# Work Order ID 102135

Item Name: Crosstube Fwd High

DRAWING NO. D212-664-141	TITLE XTUBE ASSY (205/212/412 HI FWD)	REV. D	DART AEROSPACE LTD ENGINEERING ORDER		D.E.O. NO. D212-664-141-D-1	SHEET NO. SHEET 1 OF 2	SCALE NTS
DRAWN	CHECKED	OP	MFG. APPR.	APPROVED	MA	DE APPR.	
DATE 11.04.07	DATE 11.07.11		DATE 11.04.12	DATE 11/04/12		DATE 11.04.12

**D212-664-141/-141B  
ASSEMBLY DETAIL**

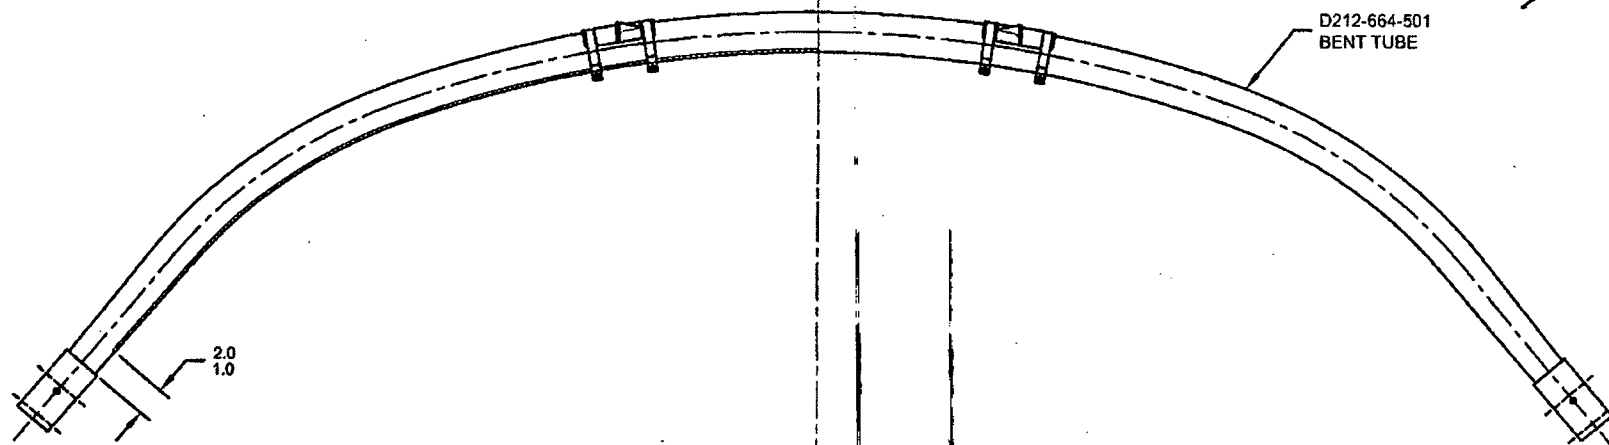
ADD AN INSPECTION WINDOW TO UNDERSIDE OF CROSSTUBE.

NOTES 2 OF SHEET 1 IS AMENDED AS FOLLOWS:

- 2) FINISH: CHEMICAL CONVERSION COAT PER DART QSI 005 4.1  
PRIME INSIDE AND OUTSIDE PER DART QSI 005 4.2  
MASK UNDERSIDE OF CROSSTUBE AS SHOWN (HATCHED AREA) AND  
PAINT OUTSIDE PER DART QSI 005 4.2  
REMOVE MASKING AND APPLY CLEAR COAT

MASK AREA PRIOR TO PAINTING.  
REMOVE MASKING AFTER PAINT  
AND APPLY CLEAR COAT
